## DESIGN + ACCESS STATEMENT ADDENDUM

1844 LECKWITH QUAY | NOVEMBER 2022

2020/01218/HYB.

#### BLOCK A:

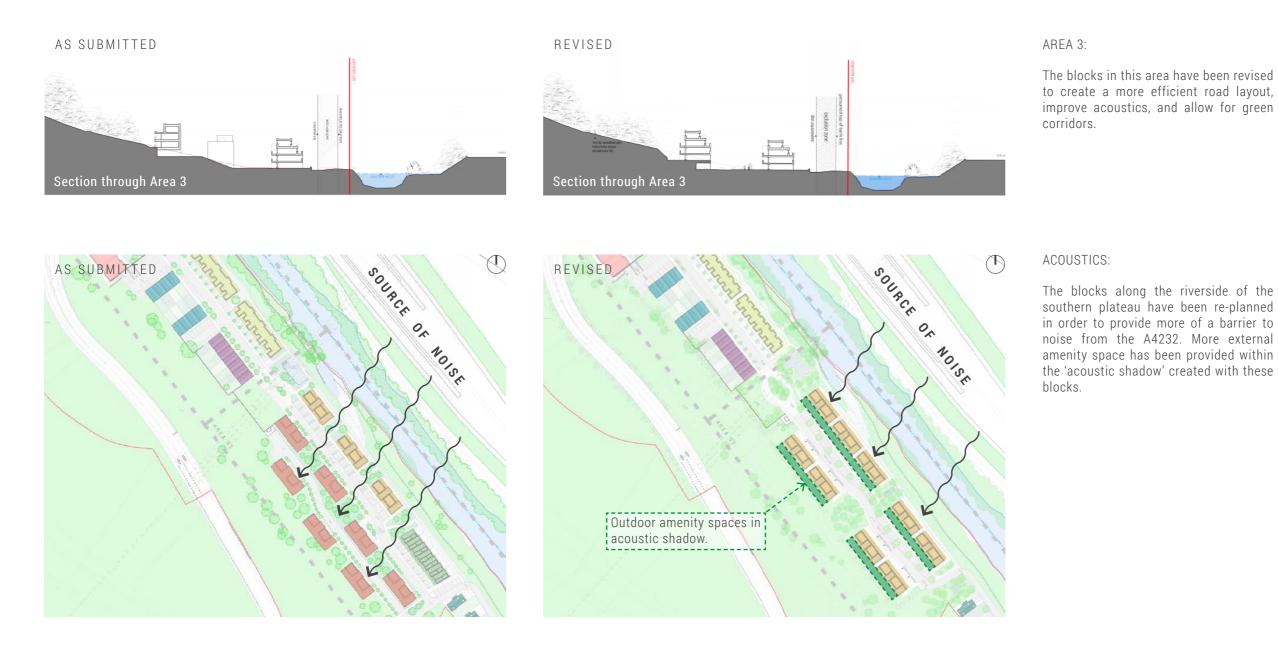
The layout of Block A has been altered slightly to bring the edge comfortably inside the red line.

Internal layout of the southern plateau has been revised to allow for a greater area of woodland to be retained / replanted, and to strengthen green corridor links between the woodland and the river for ecological benefits.

#### ABOVE GROUND DRAINAGE:

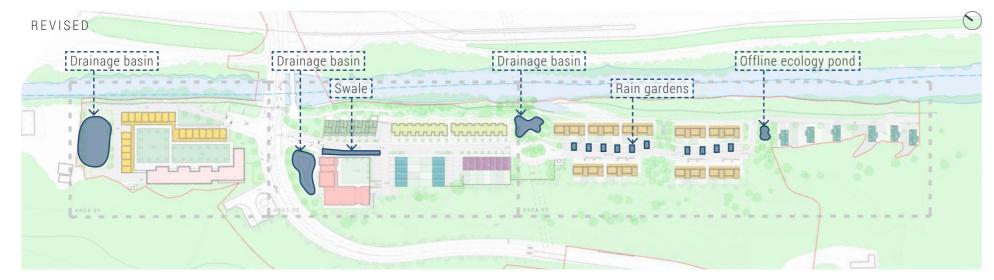
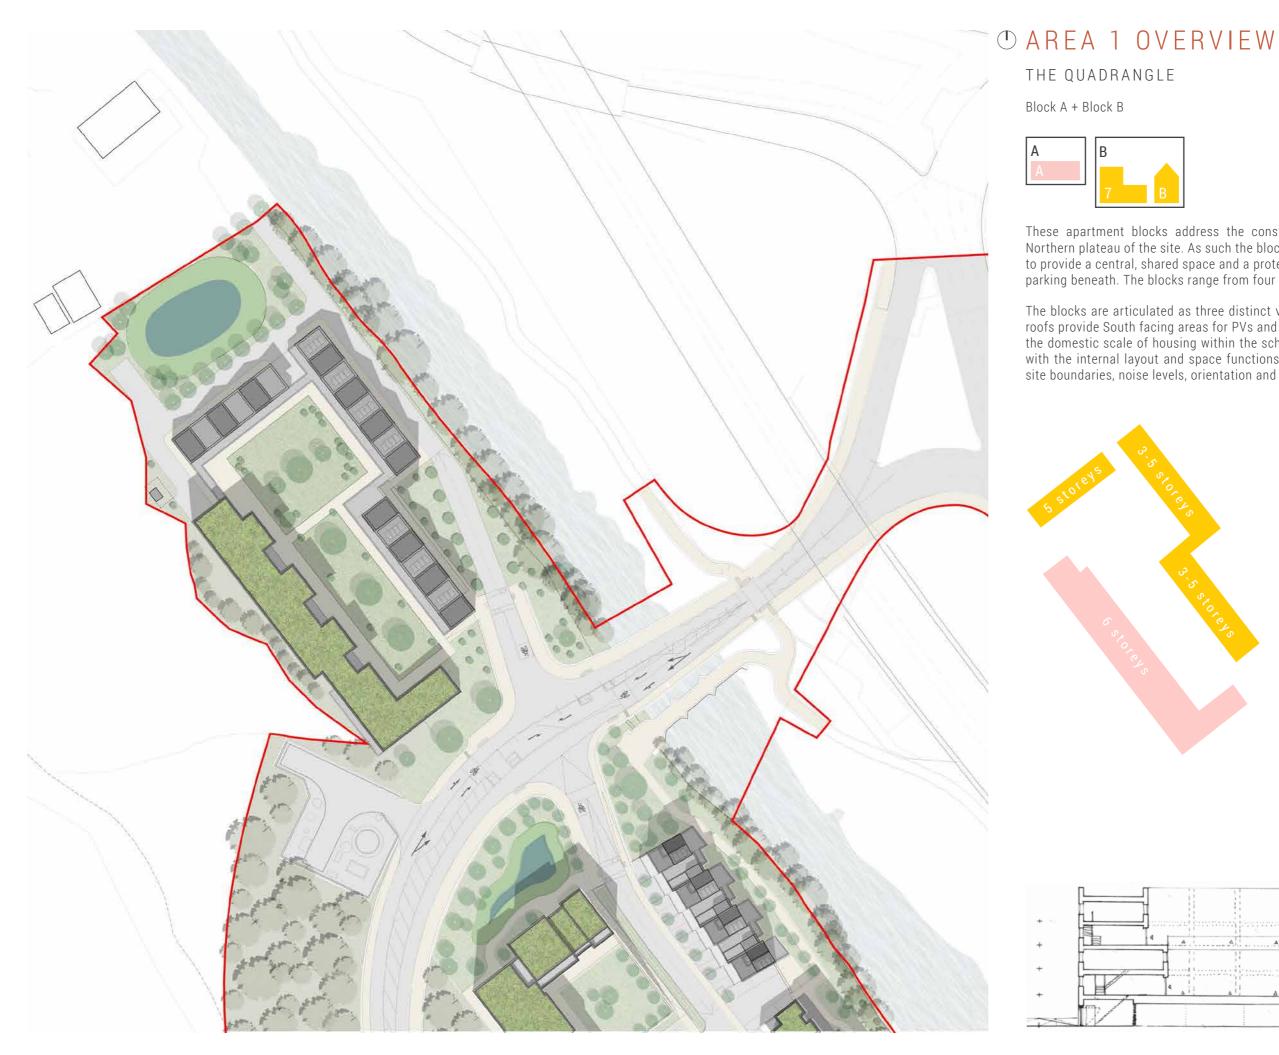
Drainage basins, swales and rain gardens have been amended in association with the changes made to the site layout and landscaping scheme. An additional offline pond is included at the southern end of the site for ecological benefit.
